MODIFICATION RECOMMENDED

66332A-10

S E R V I C E N O T E

Agilent 66332A DC Power Module

Figure 3. Through-hole Board

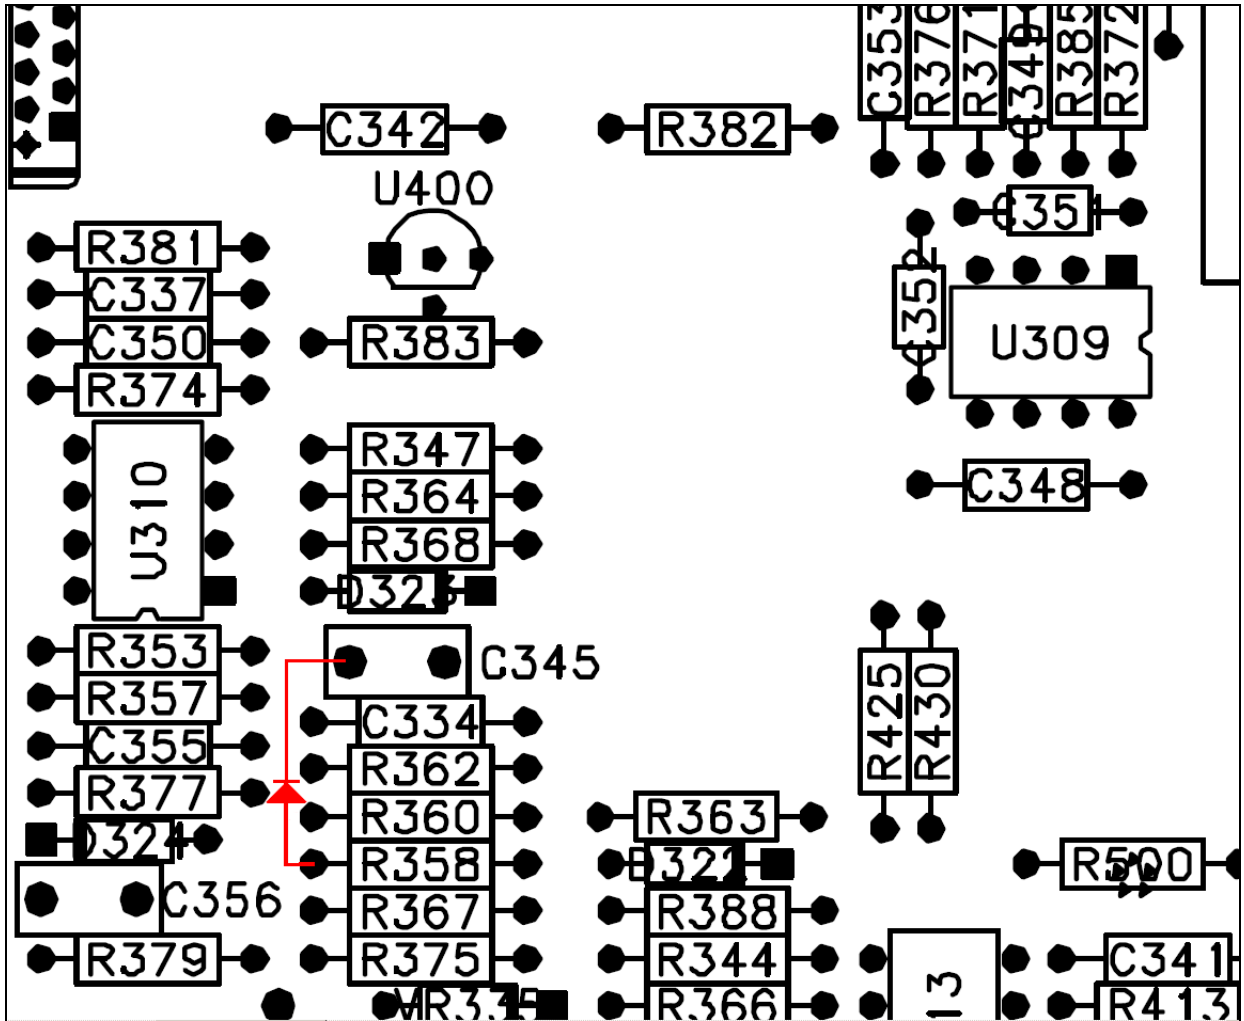
There is a possible glitch on the output due to an AC line sag between 23 VAC to 27 VAC. The time length of the glitch pulse is about 1.9s and the power supplied is 2.8W.

It is caused by a condition in which the current offset and voltage offset DACs do not reset, when the current and voltage programming DACs reset during an AC line sag. This results in an op-amp that normally operates at -5V DC to operate in the positive direction, and drives the output of the 66332A on.

The solution is to implement a diode (P/N 1901-1344) that clamps the op-amp to 0.7 V. This prevents the op-amp from driving the output on, and does not affect it due to a normal operation at -5V DC.

The figures below show where to solder the diode (P/N 1901-1344) from R358 to C345 on the A1 main board.
